Office Action Summary	Application No. 10/807,311	Applicant(s) YOSHIMURA, ATSUSHI	
	Examiner José R. Díaz	Art Unit 2815

DETAILED ACTION

2. Claims 9-11, 13 and 15-16 are rejected under 35 U.S.C. 102(e) as being anticipated by Isaak (US Pat. No. 6,472,735 B2).

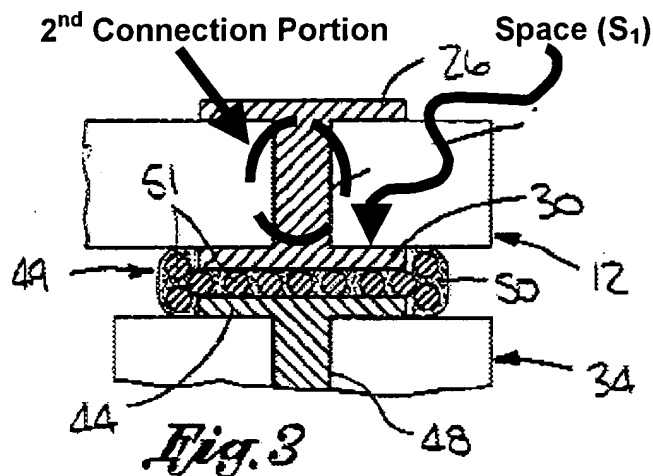
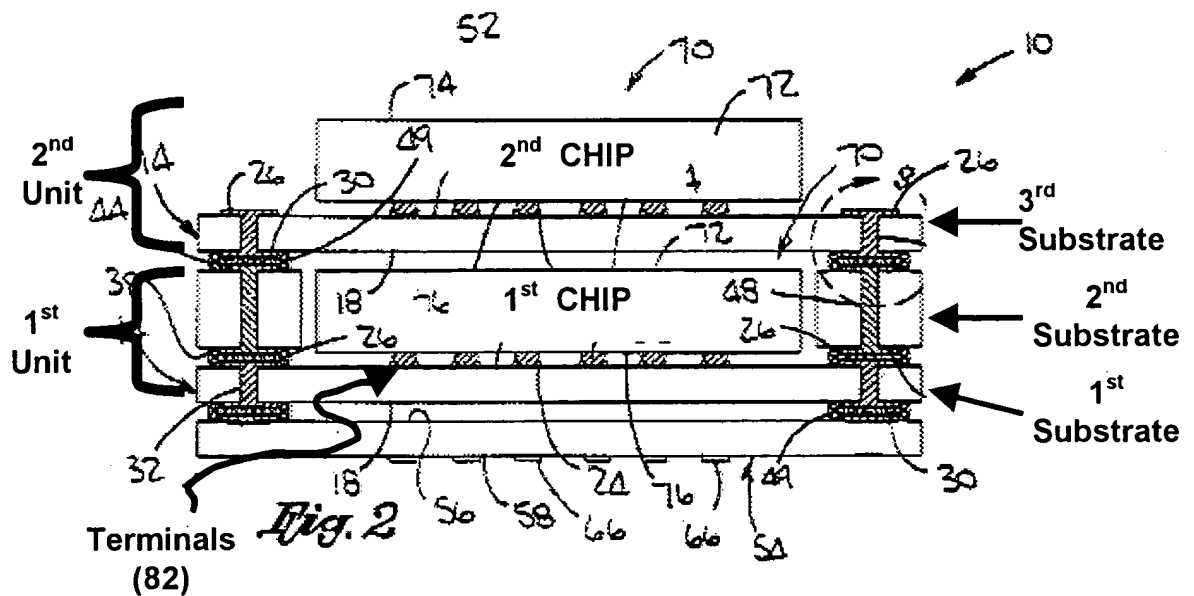
Regarding claim 9, Isaak teaches a semiconductor device comprising:

a first substrate (1st substrate 14) including an integrated circuit chip (1st chip 72) [See figure 2, attached below], first connection terminals (Terminals 82) electrically connected to terminals of the integrated circuit chip (24) [see fig. 2], and a first connection portion (consider through hole 32 formed in 1st substrate 14) spaced from the first connection terminals (Terminals 82) [see fig. 2];

a second substrate (2nd substrate) stacked on the first substrate [see fig. 2, attached below] and including second connection terminals (please consider terminals 51) and a second connection portion (consider 2nd connection portion formed in the 2nd substrate as shown in figure 3, attached below) spaced from the second connection terminals (51) [consider the space S₁ which is formed between the bottom surface of the 2nd connection portion and the upper surface of the second connection 51 shown in fig. 3, attached below]; and

a metal material portion (26) provided between the first connection portion and the second connection portion (fig. 2) and bonding the first connection portion to the second connection portion [please note that portions 30 and 44 of metal 26 are shown bonded with an epoxy component (49 and 50) in figure 3, attached below].

Regarding claim 10, Isaak further teaches a plurality of unit substrates (1st Unit and 2nd Unit as shown in fig. 2, attached above) that are stacked, each of the unit substrates being formed of the first (14) and second (34) substrates stacked (see fig. 2, and col. 8, lines 2-3. Please note that although it is not shown in the figures, Isaak, in col. 8, ll. 2-3, further teaches that an additional second substrate 34 can be provided on the 3rd substrate).

Regarding claim 11, Isaak further teaches an adhesive sheet (49,50) interposed between the unit substrates (1st Unit and 2nd Unit) adjacent each other a stacking direction and bonding the unit substrates together (see figs. 2 and 3, attached above).

Regarding claim 13, Isaak further teaches that the first connection portion is a first dummy pad (30) provided on the first substrate (14) [see fig. 3], and the second connection portion is a second dummy pad (44) provided on the second substrate (34) [see fig. 3].¹
